<b>Docket Number:</b>	09-AFC-08C
<b>Project Title:</b>	Genesis Solar Energy Project
<b>TN #:</b>	203312
<b>Document Title:</b>	Petition to Amend for Spare Transformer
<b>Description:</b>	Petition to Amend to allow Genesis (GSEP) to store an auxiliary 25-MVA three-phase transformer on site
<b>Filer:</b>	Eric Veerkamp
<b>Organization:</b>	California Energy Commission
<b>Submitter Role:</b>	Commission Staff
<b>Submission Date:</b>	11/4/2014 3:30:22 PM
<b>Docketed Date:</b>	11/4/2014

Re: Petition to Amend The Commission Decision For Genesis Solar Energy Center,  
Docket No. 09-AFC-8.

## **GENESIS SOLAR ENERGY FACILITY APPLICATION FOR STAFF APPROVED PROJECT CHANGE**

SITE PLAN  
SCALE: 1" = 20'-0"

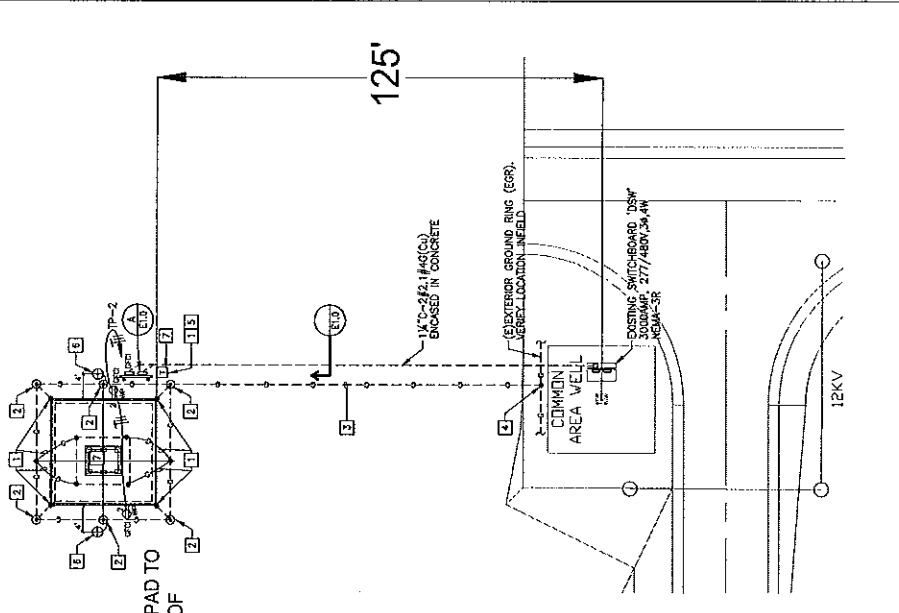
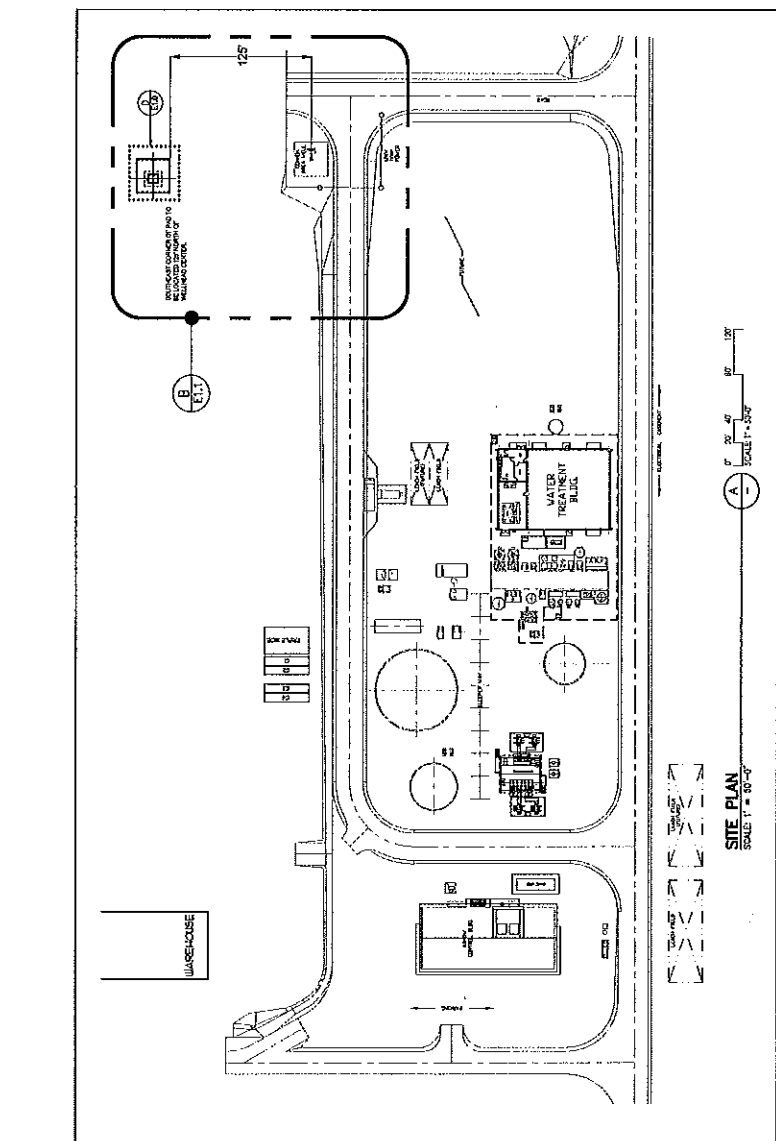
The modification proposes to store one (1) spare three-phase 25 MVA Auxiliary Transformer at the Genesis site, which can be used as a replacement for the on-line unit in case of emergency failure. It will be mounted on a concrete foundation with secondary containment, to capture oil in case of spillage. Low power electrical supply will be provided for heating elements inside the control cabinet to prevent moisture build-up, and also to periodically check cooling fan operation. Attached are the spare foundation plans which include a Site Plan, transformer nameplate which provides product specifications, and the transformer outline. Genesis will use Bureau Veritas as the Chief Building Official (CBO) for the project.

SOUTHEAST CORNER OF PAD TO BE LOCATED 125' NORTH OF WELLHEAD CENTER.
